project: **ALMAGUIN HIGHLANDS OUTDOOR COMMUNITY HUB**
28 MUNICIPAL LANE
SUNDRIDGE, ONTARIO

title: PARTIAL SITE PLANS
STONE DUST PATH CLARIFICATION

title: PARTIAL SITE PLANS AND DETAILS
BARRIER FREE PATHWAY AT ENTRANCES

project: **ALMAGUIN HIGHLANDS OUTDOOR COMMUNITY HUB**
28 MUNICIPAL LANE
SUNDRIDGE, ONTARIO
title: ELEVATION AND SECTION DETAILS
ROOFING DETAILS

dwg no:
AD3.0

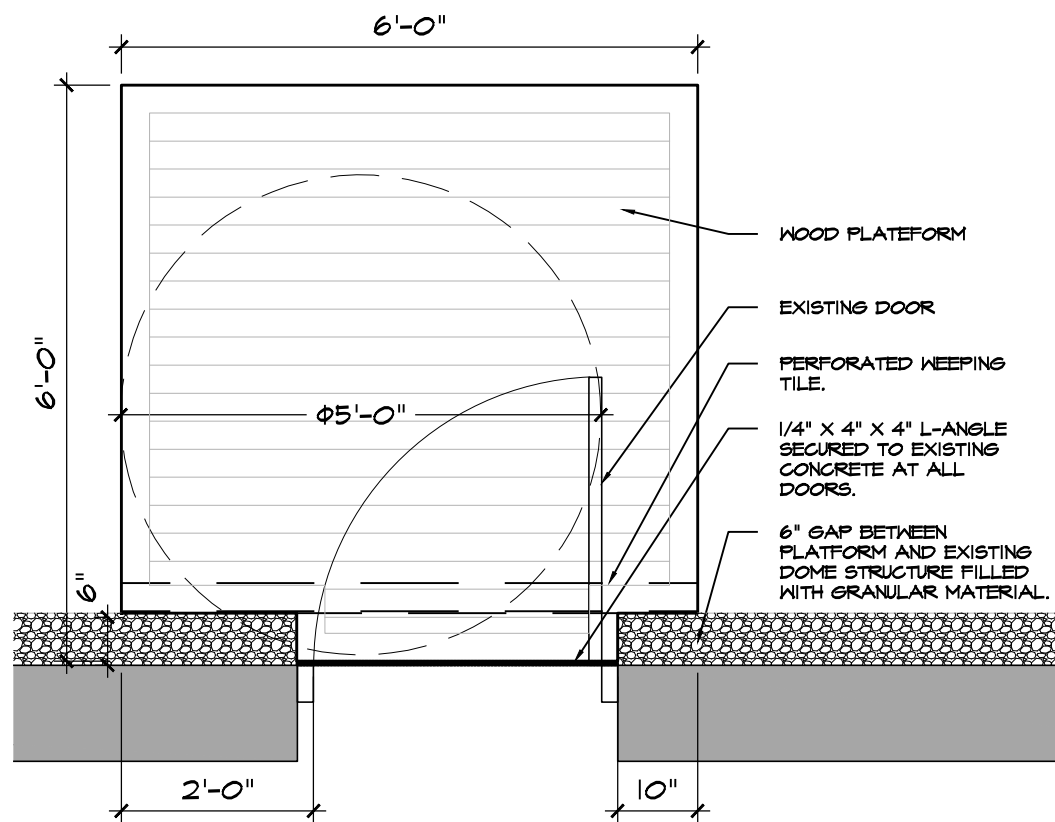
- .1 All new unit paver sidewalk along edge of existing megadome structure to be installed with a 152mm gap between sidewalk and building edge. Refer to sketch AD3.1 for details at entrance landings.
- .3 Drawing A1.1, Partial Site Plans
 - .1 Extent and location of stone dust pathways to be clarified per attached sketch AD3.0.
 - .2 Revised hardscaping between existing dome and new hub structure per attached sketch AD3.1.

dwg no:
AD3.2

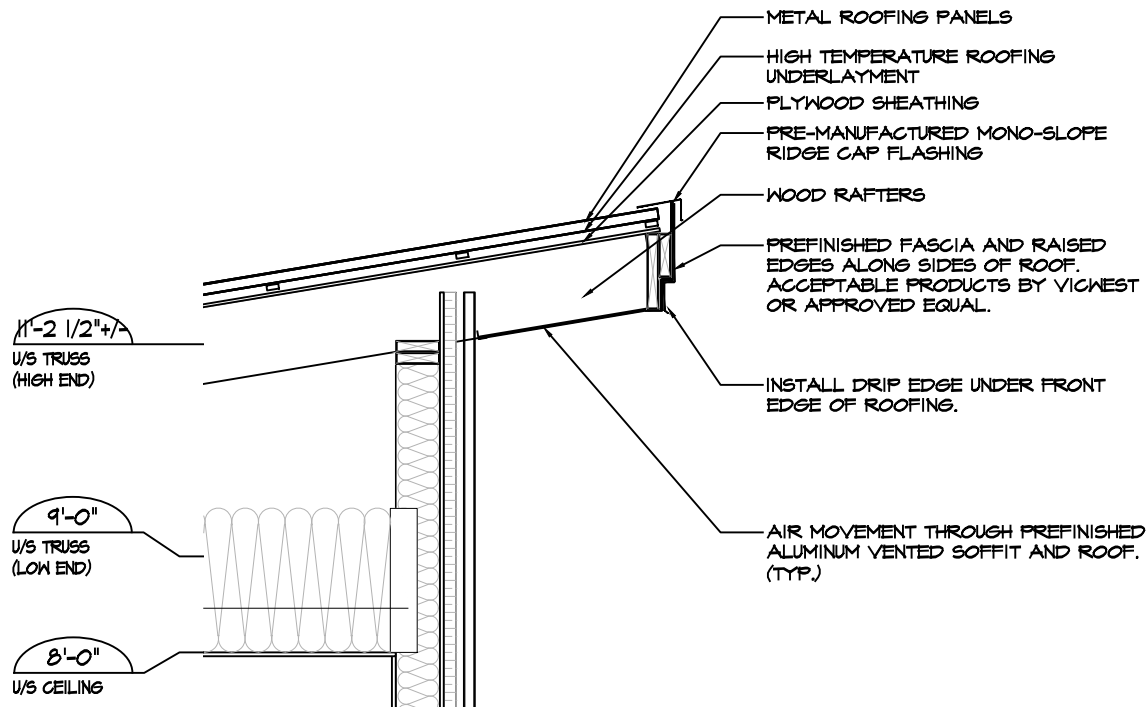
ADD: ".10 Contractor to provide fascia, corner trim, cove trim, moulded trims soffit per the architectural details and colours listed in the architectural drawings and attached sketch AD3.2.

- COLOURS**
- FASCIA COLOUR TO MATCH THE FOLLOWING:
 - CORNER TRIMS
 - BASE TRIMS
 - TRIMS AROUND FENESTRATION
 - FASTENERS
 - GUTTERS
 - SIDING COLOUR TO MATCH THE FOLLOWING:
 - PAINTED VENTS
 - DOWNSPOUTS
